826-1792, MJCF, MJ45 Switch Replacement

Follow this wiring diagram to install switch 807-3498 as a power switch on a Frymaster MJCFE or MJ45 fryer.

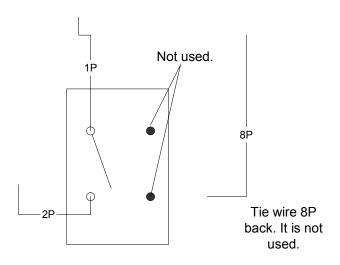
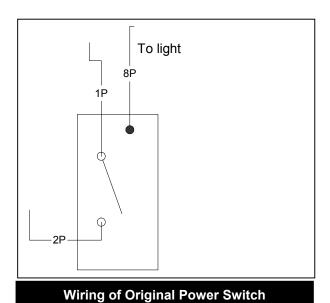
Wire the new switch, 807-3498, as shown below.

The original switch was wired as shown at left. This illustration is included to identify placement of wires on the 807-1404 switch.

Wire the 807-3498 switch as shown in the diagram (immediately below) when installing as a melt cycle switch on a Frymaster MJCFE or MJ45 fryer. The wiring of the original switch is provided as a reference.

The 9P jumper wire is removed and discarded.

8P and 7P are disconnected from the original switch and spliced together.

The original switch, 807-0046, was wired as shown at left.
